Memorandum

From: Gerald Williams, WEI
To: Holders of the Final Drainage Report for the Cotton Woods Subdivision

Re: Minor Revisions Subsequent to the January 2002 Final Drainage Report Submittal

Date: April 15, 2002

EXHIBIT "10A"

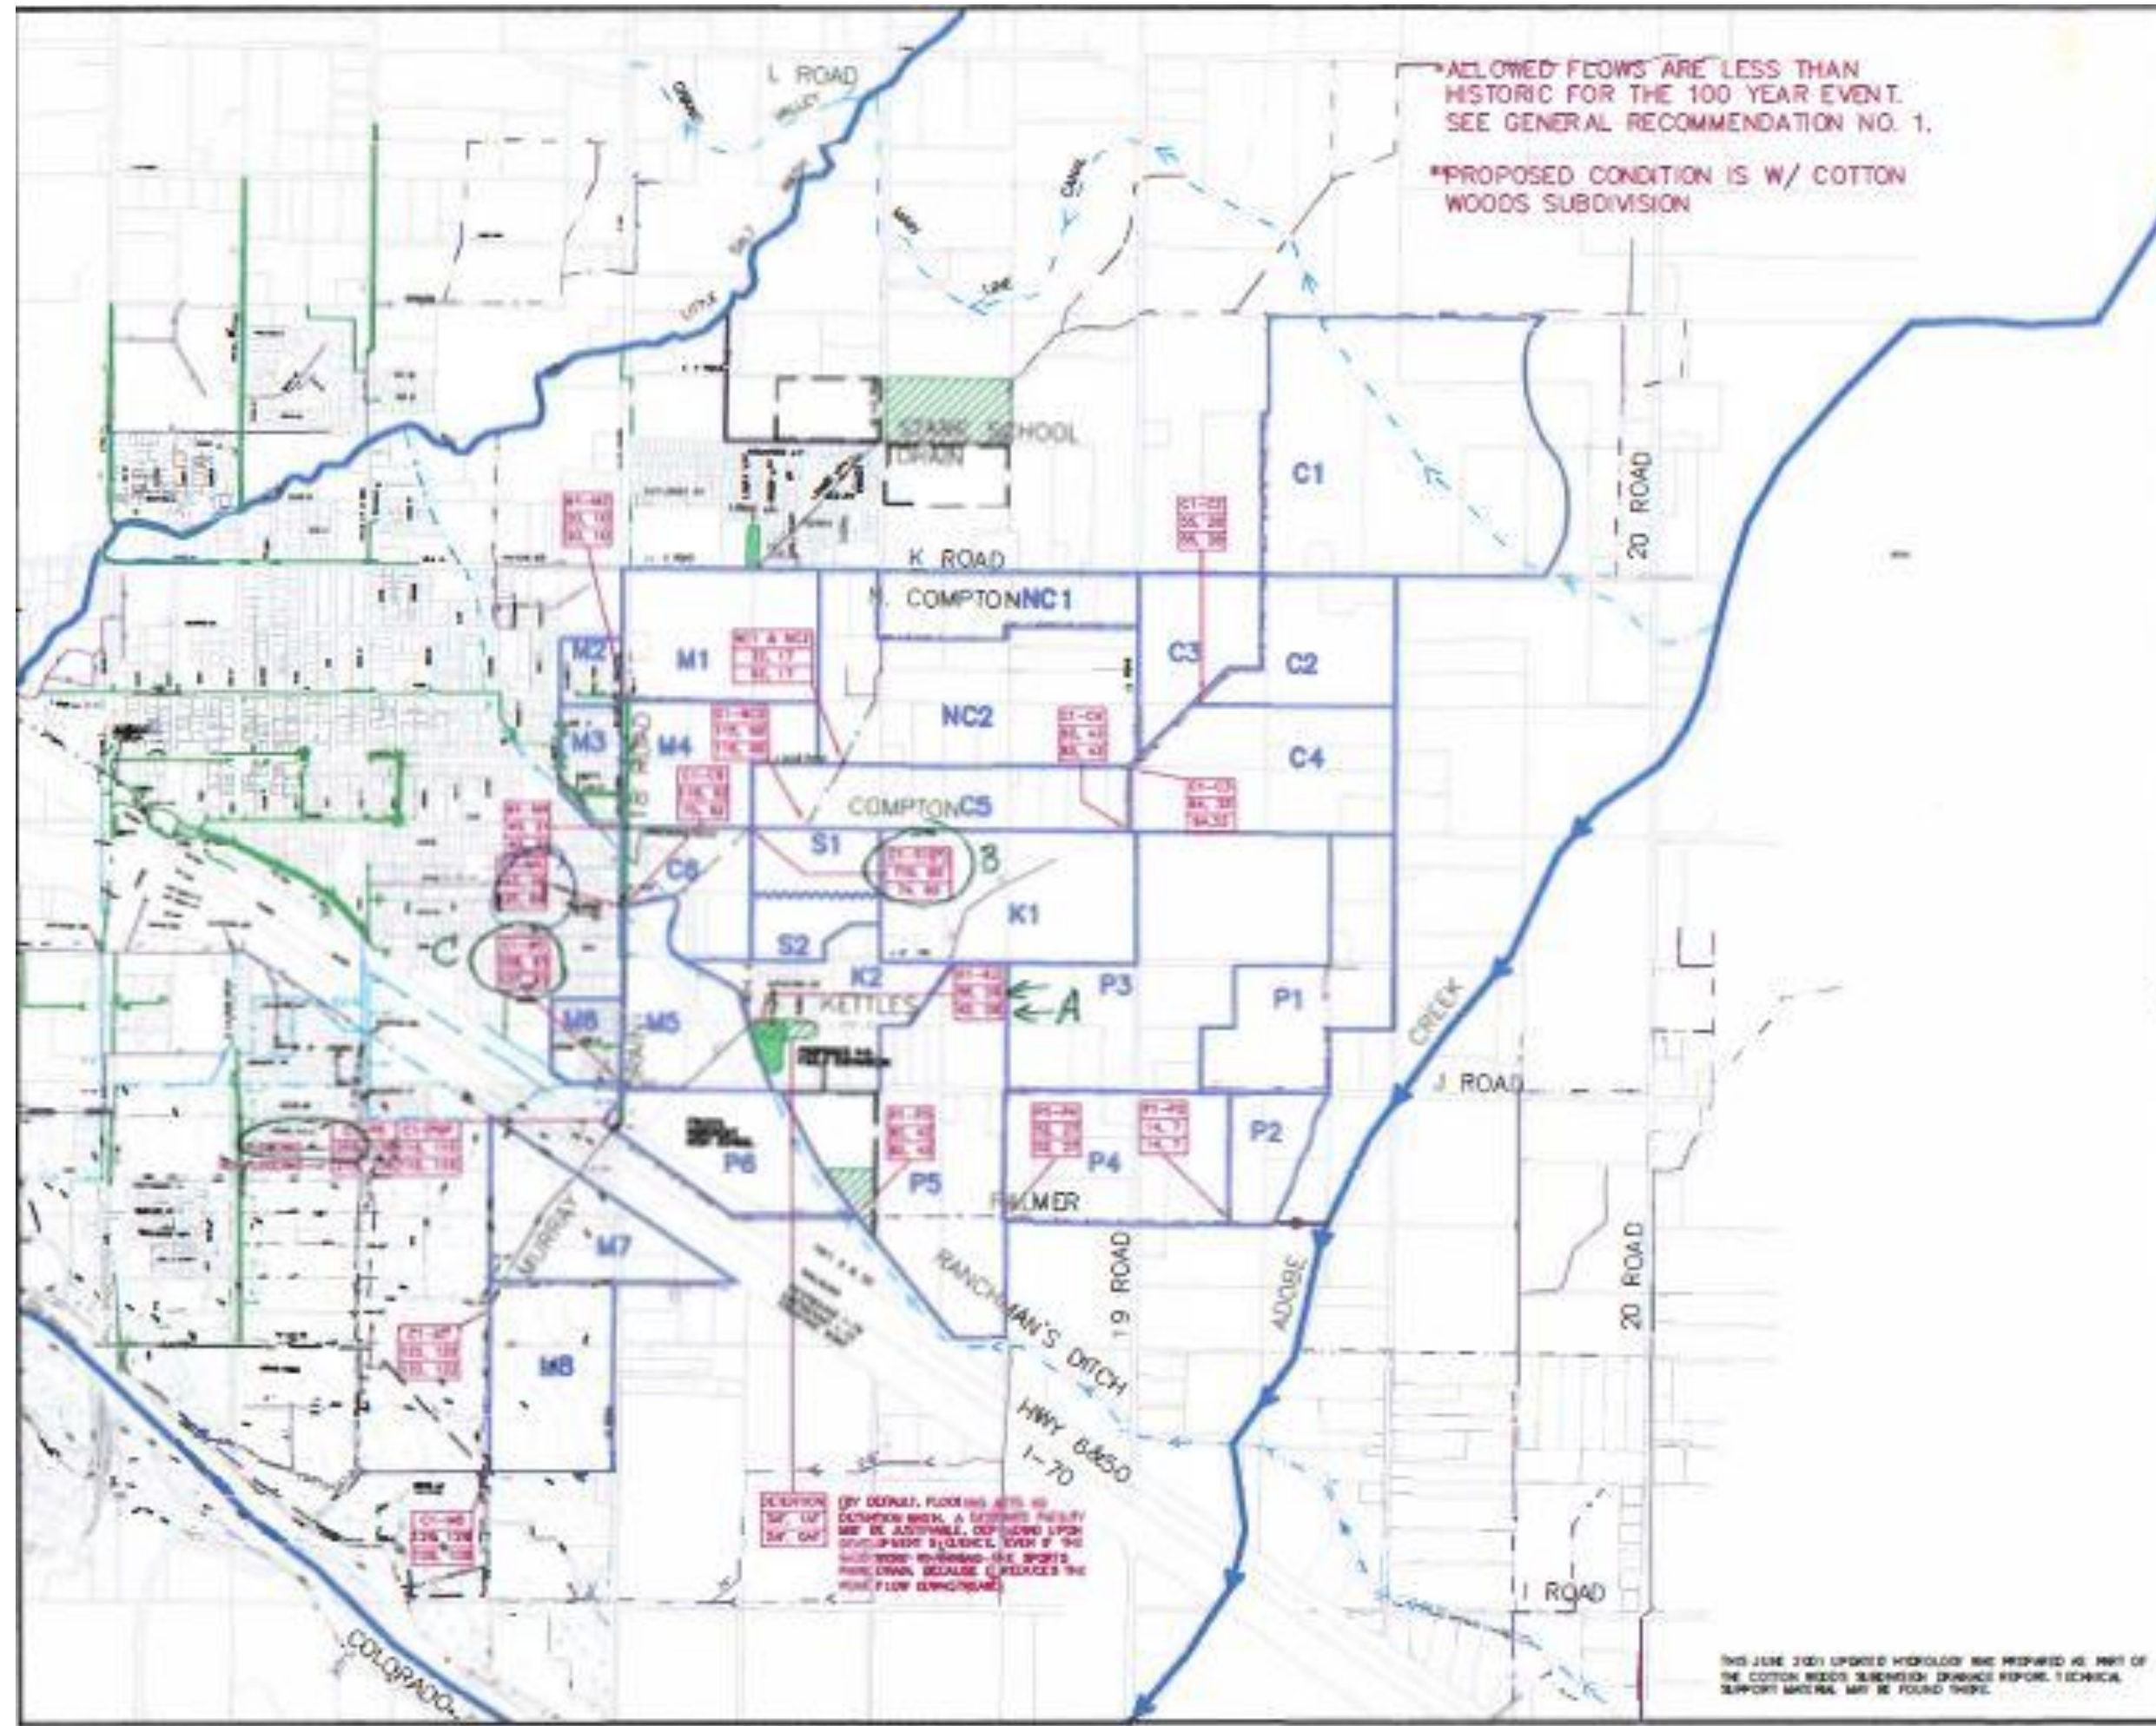
Exhibits A and C have been updated to reflect final conditions for complete development of Cotton Woods Subdivision. Each summarizes information that is provided in the appendices.

Over-Detention The proposed Cotton Woods subdivision would provide 55 cfs more detention than required. The total required drop in runoff at the highway is $0.48 \times 255 = 122$ cfs. (The additional drop to the 110 cfs culvert capacity under the railroad comes from the detention capacity of the open drains between the railroad and the highway, which should be preserved.) The Cotton Woods must provide 13 cfs of the 122 cfs drop, and 109 cfs must come from others. This means that the over-detention represents 55 cfs/109 cfs or 50.5% of all excess detention required in the balance of the Murray Drain system. This is a significant amount.

EXHIBIT C

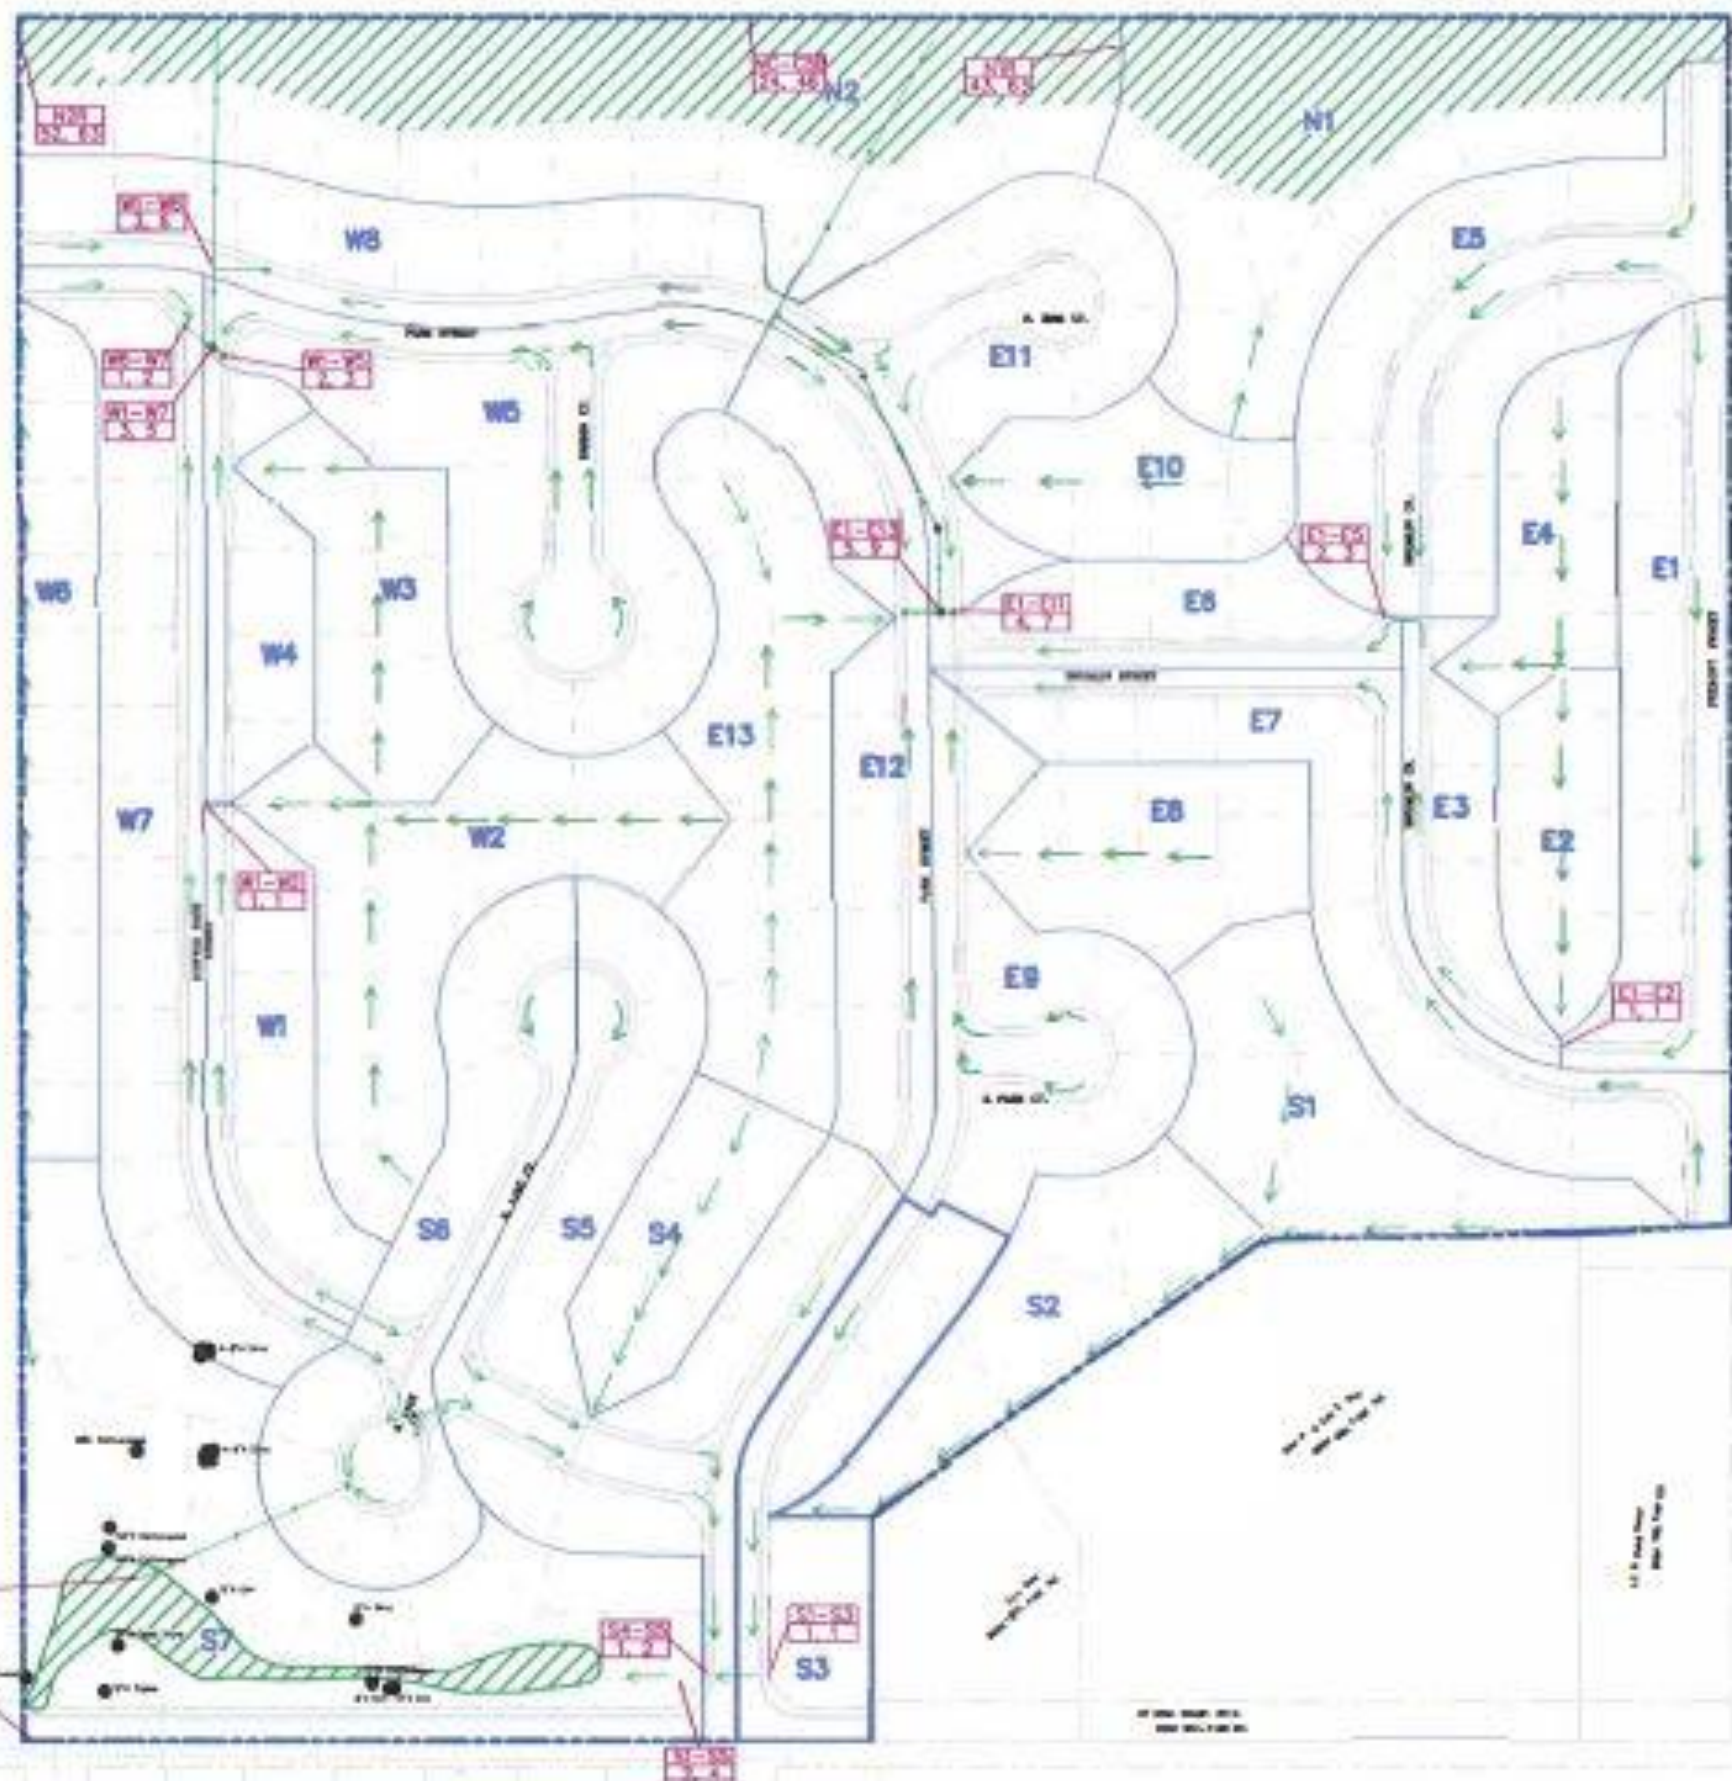
The final lot layout, grading, and irrigation pond scheme all took its toll on anticipated available detention volume. Instead of 11 or 12 acre feet, we ended up with a 1.90 acre foot upper basin and 4.16 acre foot lower basin. This change has significantly lowered but not entirely removed the over-detention proposed earlier.
